ADDENDUM

TO THE DRAFT COVE PALISADES STATE PARK MASTER PLAN

February 15, 2002

PROPOSED OWNERSHIP

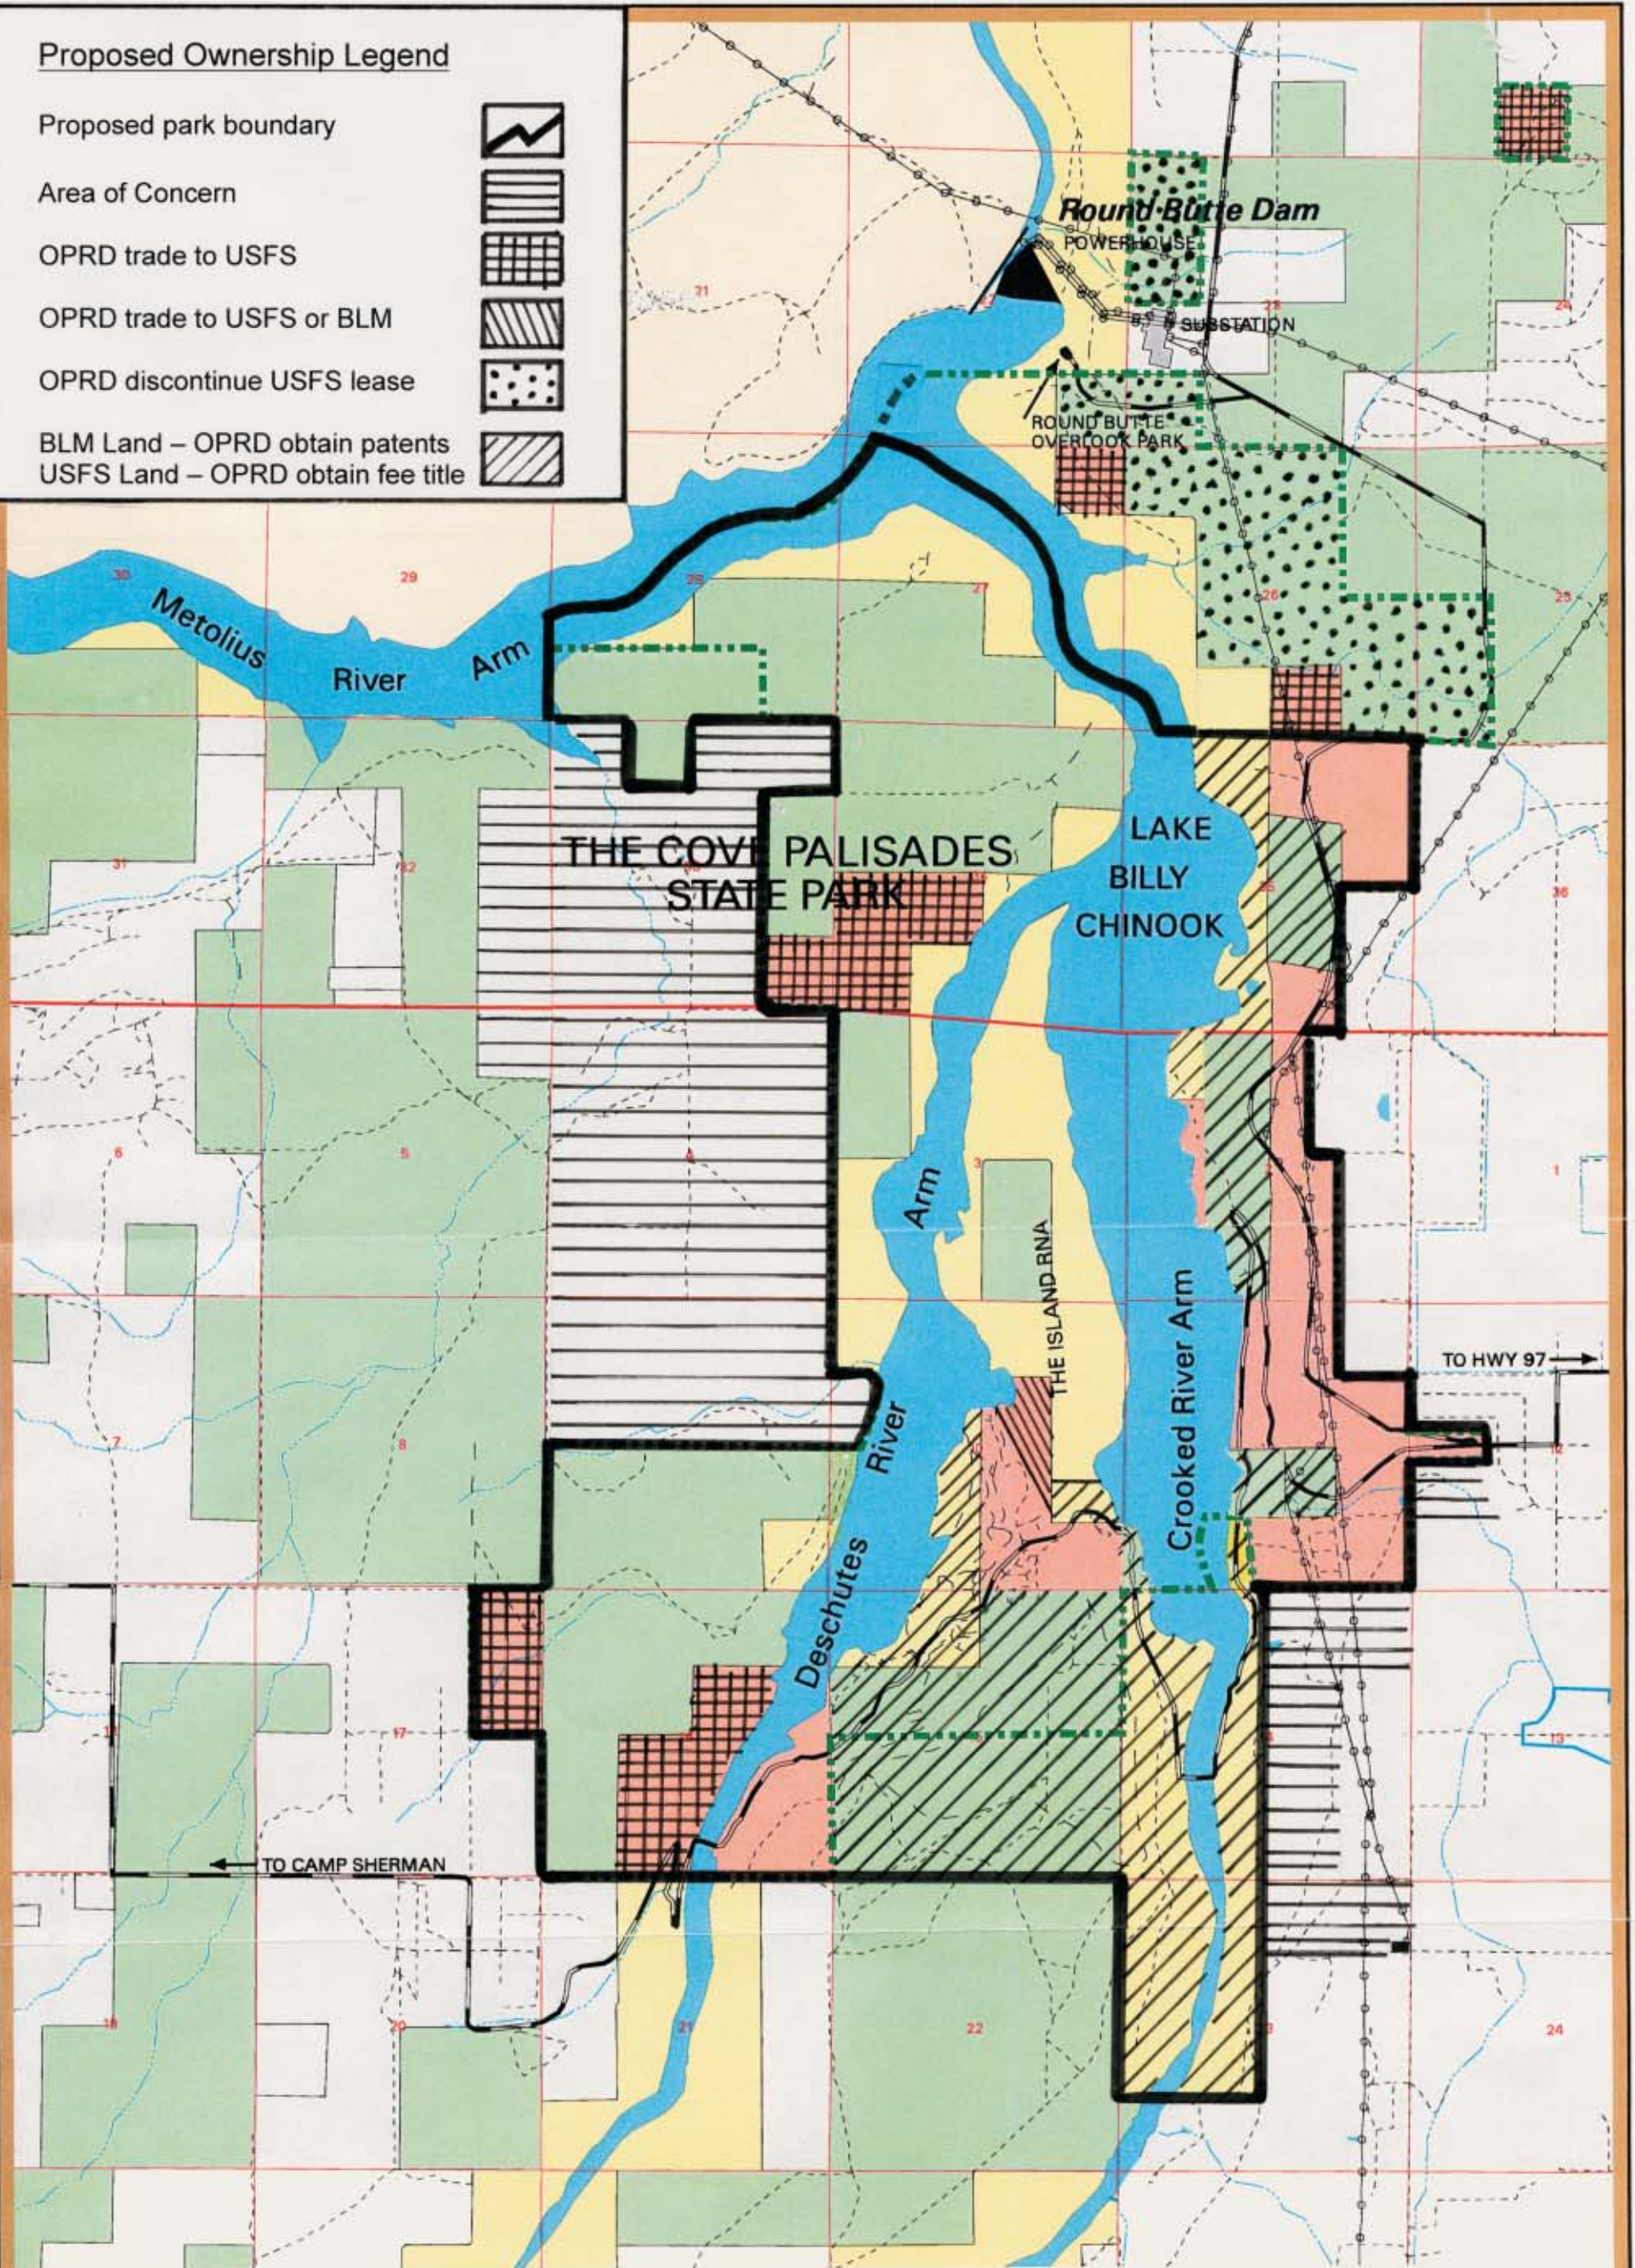
Page 48, replace the “Proposed Ownership” map with the updated “Proposed Ownership” map attached at the end of this addendum.

VICINITY OWNERSHIP

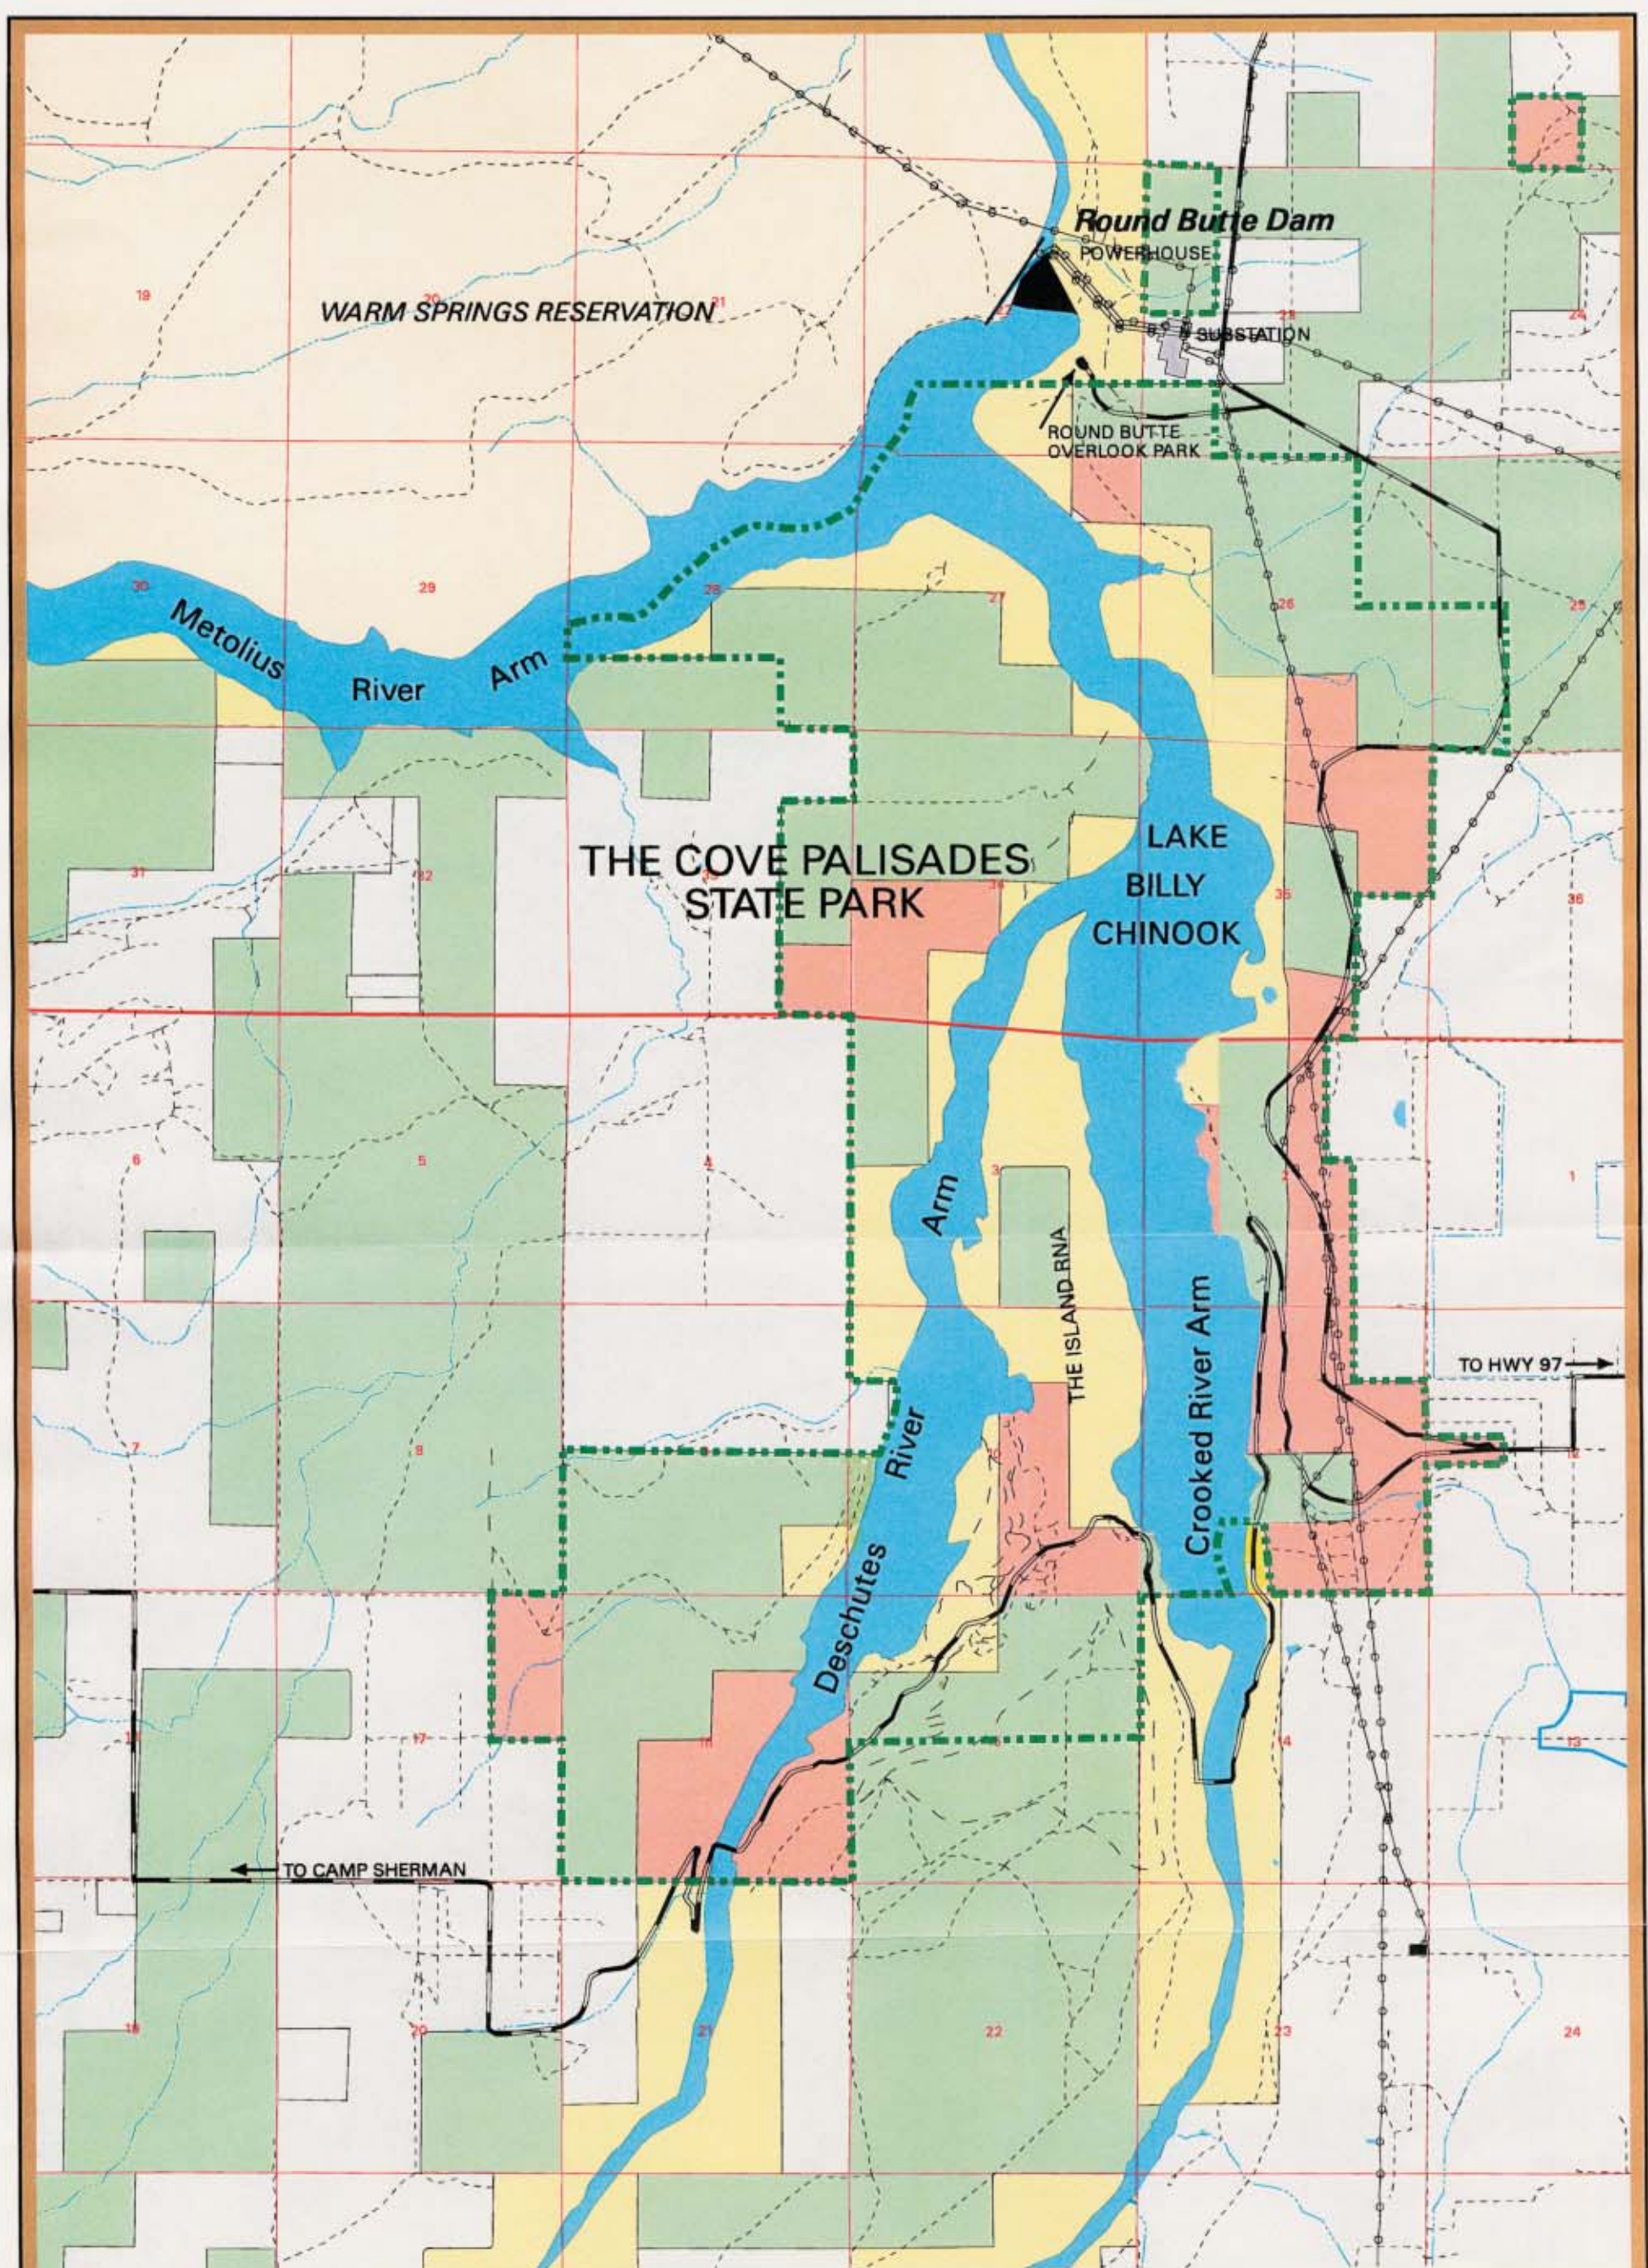
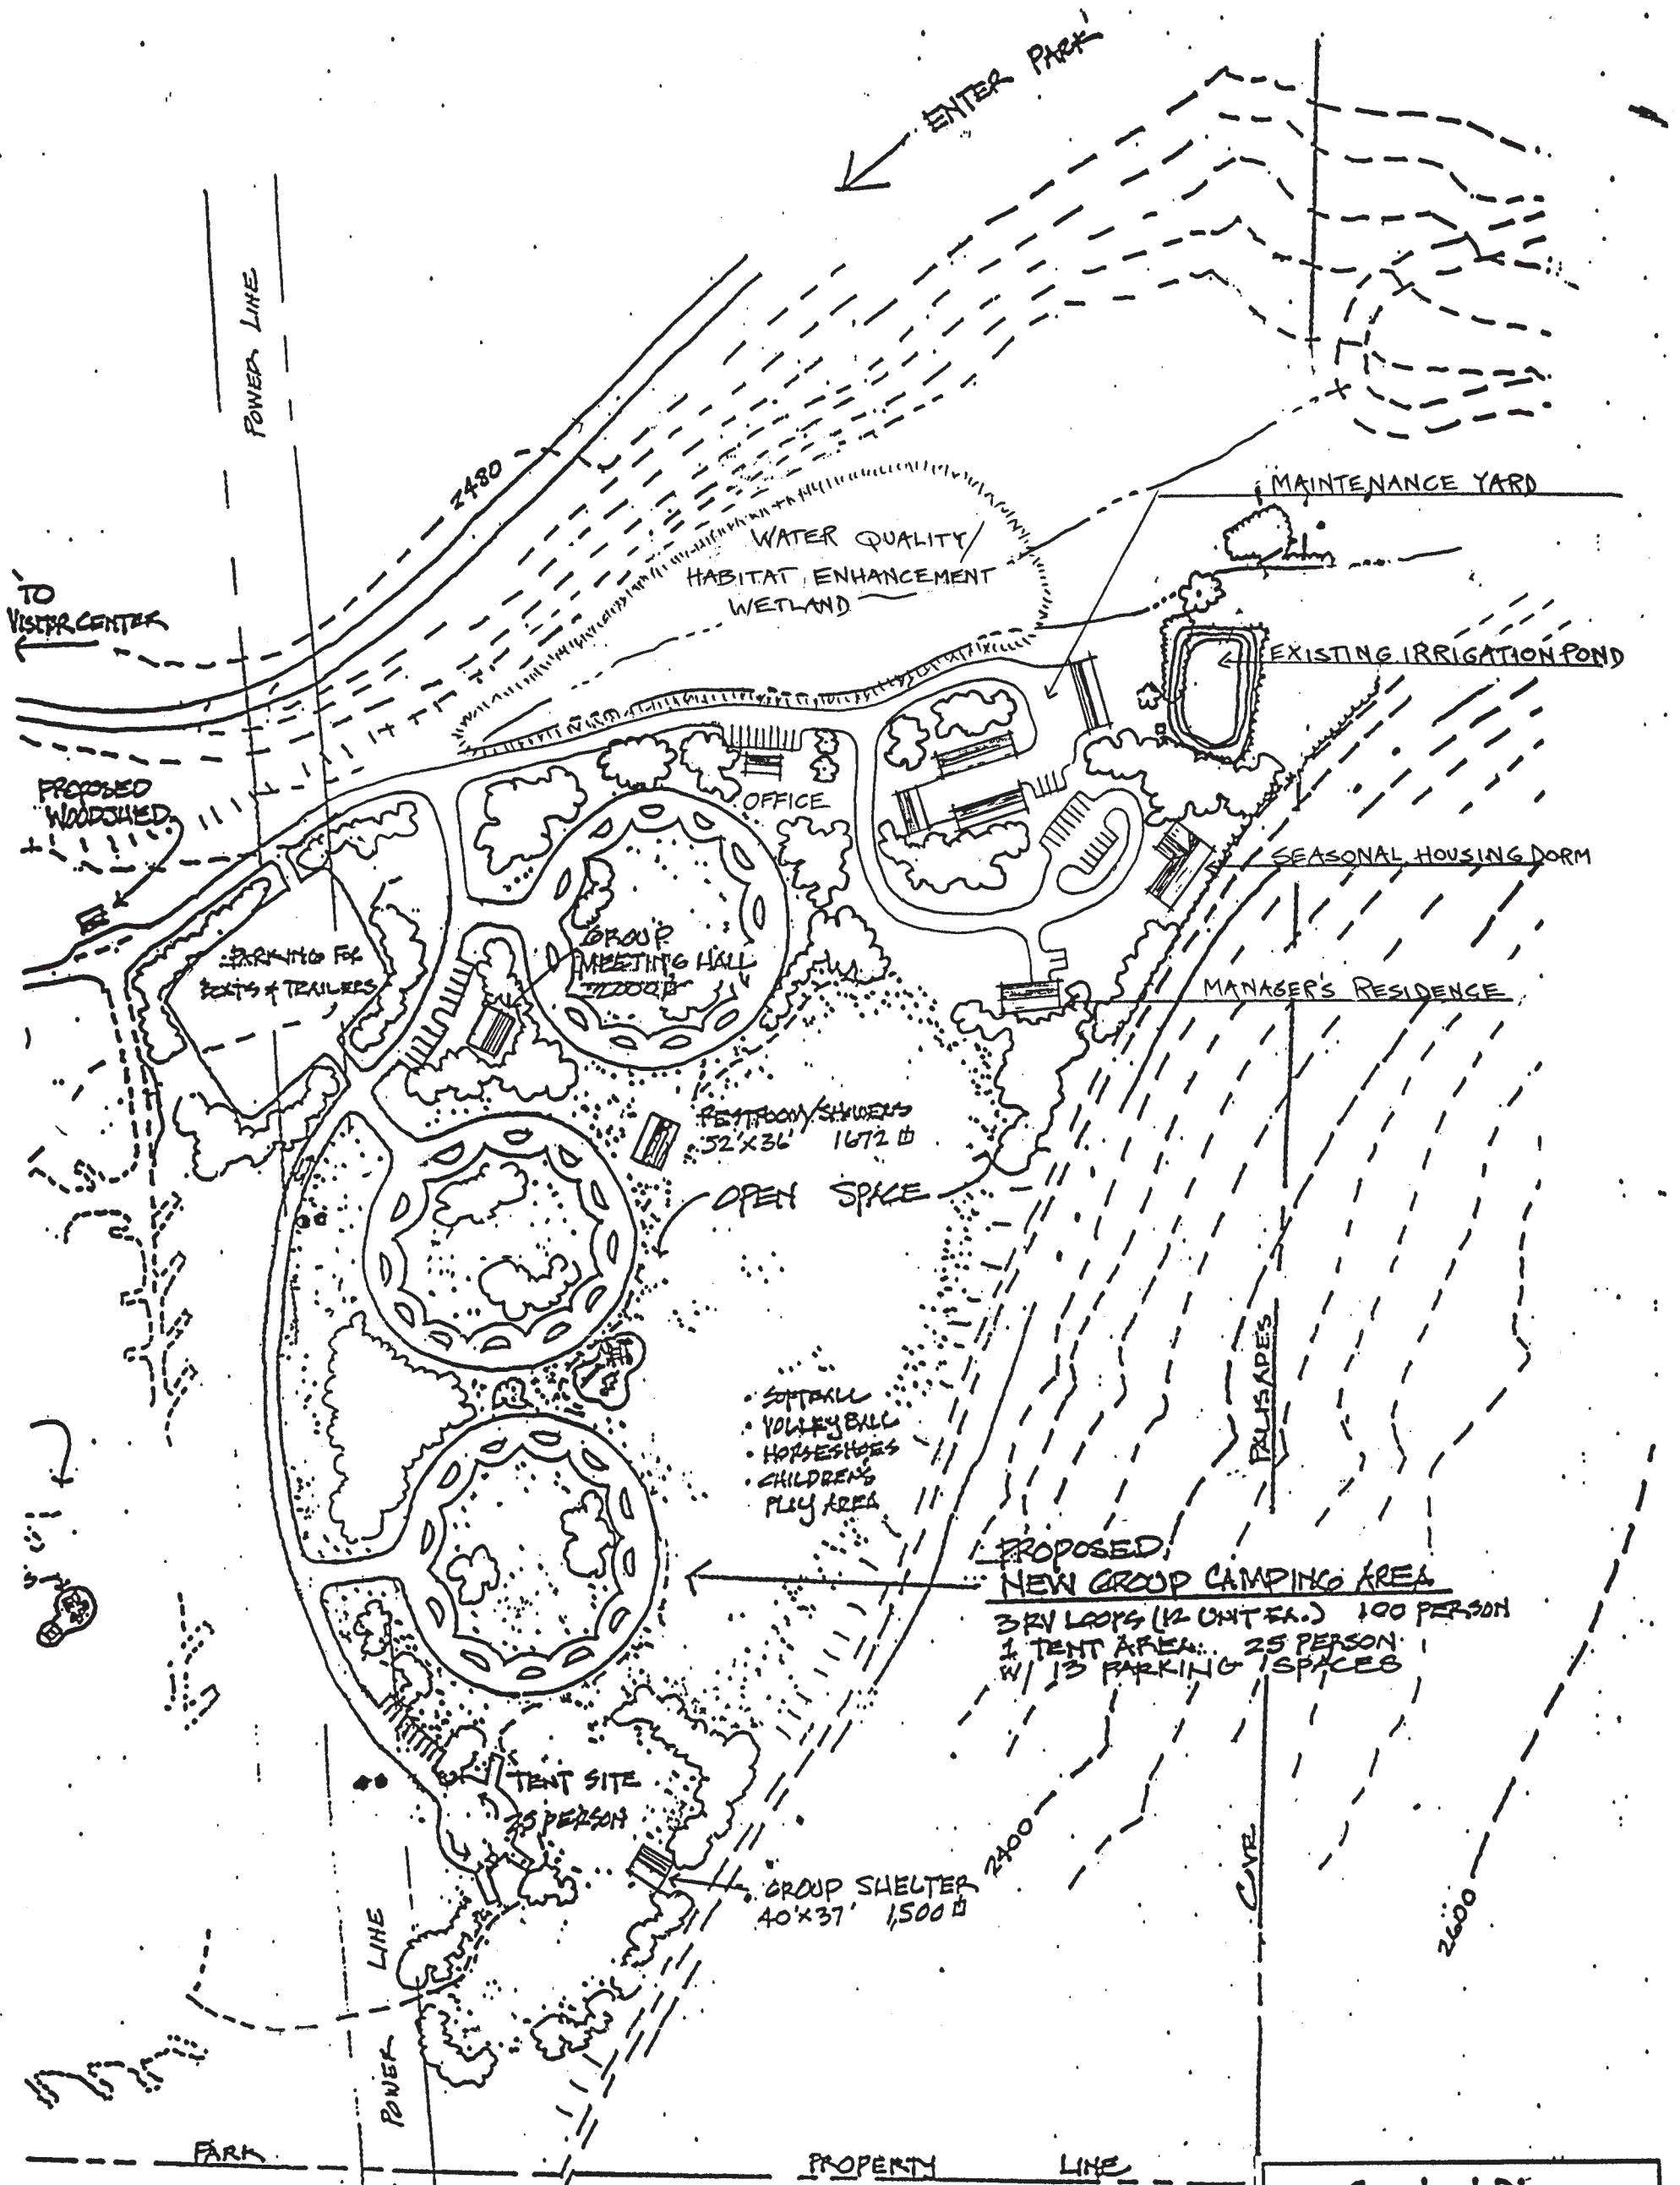
Page 5, replace the “Vicinity Ownership” map with the corrected “Vicinity Ownership” map attached at the end of this addendum.
